ARCHITECTURAL REVIEW BOARD MEETING  
CITY HALL, 385 SOUTH GOLIAD STREET, ROCKWALL, TEXAS  
DECEMBER 10, 2024 IN THE CITY COUNCIL CONFERENCE ROOM AT 5:00 PM

## PLANNING AND ZONING COMMISSION CASE MEMO

**TO:** Planning and Zoning Commission  
**DATE:** December 10, 2024  
**APPLICANT:** Jeff Carroll, *Carroll Architects*  
**CASE NUMBER:** SP2024-048; *Site Plan for River Dog Retreat*

**LANDSCAPE SITE PLAN**

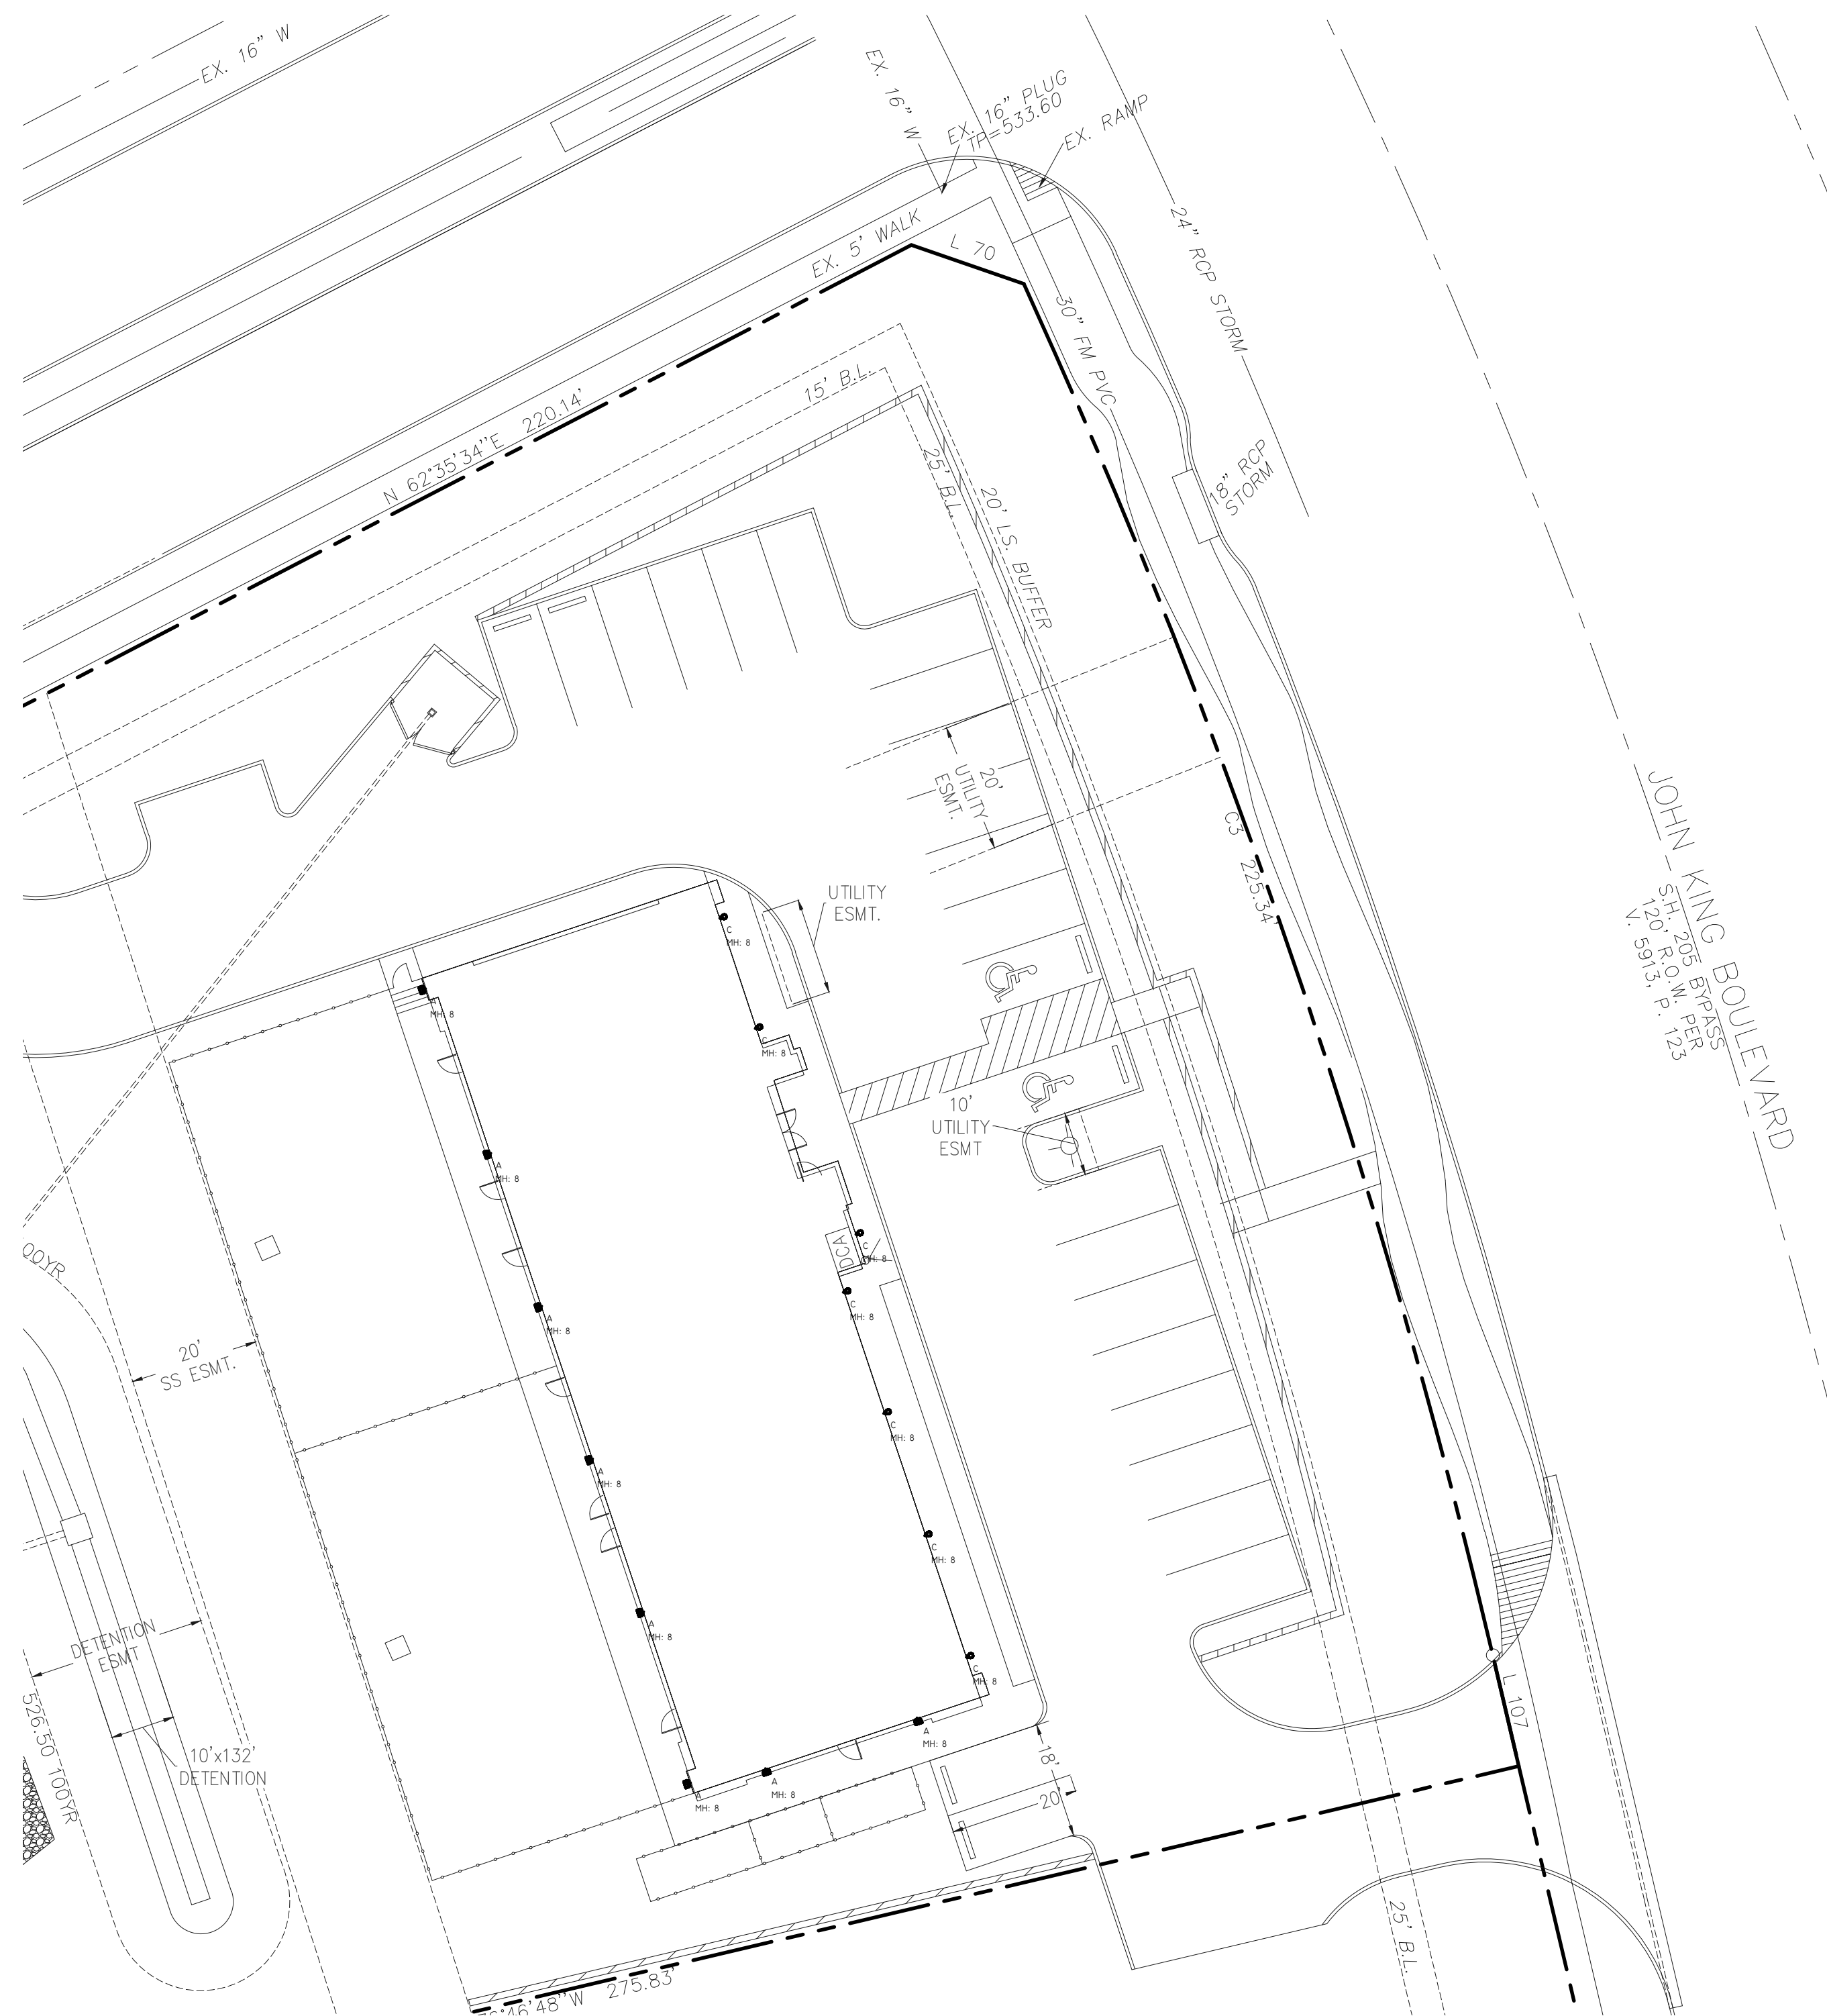
masonry fence a minimum of six (6) feet in height with canopy trees planted on 20-foot centers...” In this case, the applicant is proposing to utilize the existing tree line as the residential adjacency screening, in lieu of the required screening. This will require an exception from the Planning and Zoning Commission.

- (b) Artificial Turf. According to Section 04(B), *Prohibited Planting Materials*, of Article 08, *Landscape and Fence Standards*, of the Unified Development Code (UDC), “(a)rtificial or synthetic plant materials (e.g. artificial grass, turf, trees, and/or shrubs) shall be prohibited on all non-residentially zoned or used property in the City of Rockwall...” In this case, the applicant is proposing artificial turf in the play areas. This will require an exception from the Planning and Zoning Commission.

We are requesting use of the existing massive tree vegetation along the creek to replace the three-tier landscaping required in the ordinance.

We are requesting an exception from the UDC to allow artificial turf for this project. Being a dog retreat, this is very integral to the operation. The turf will be PFAS free per city comment.
